Illustrated Parts List - IPL Update

288XP/XPG

Removal of Plug 503 27 90-04.
Reason: The plug does not fill any function anymore.

1. Crankcase

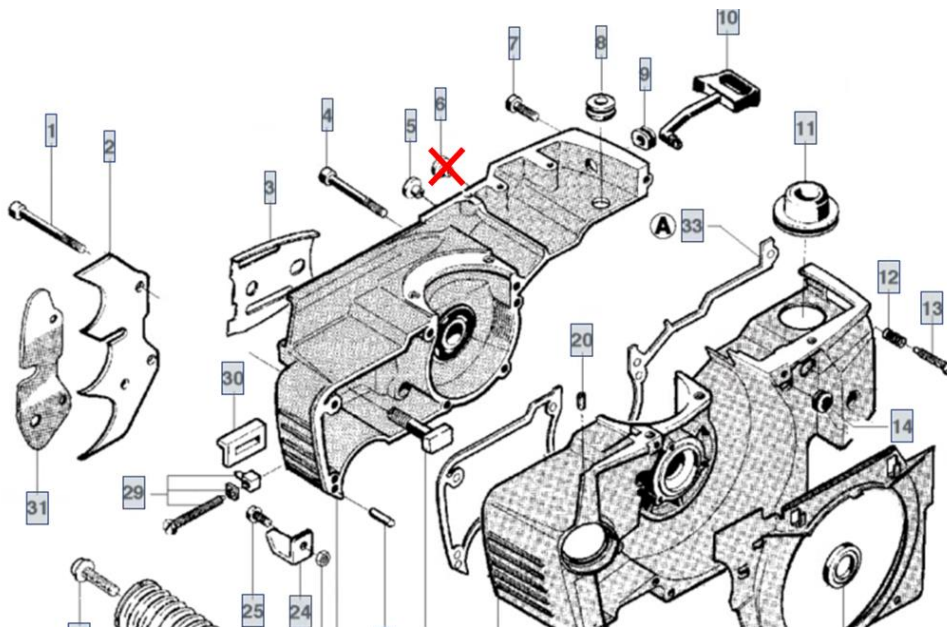
Remove plug 503 27 90-04 (pos. 6).
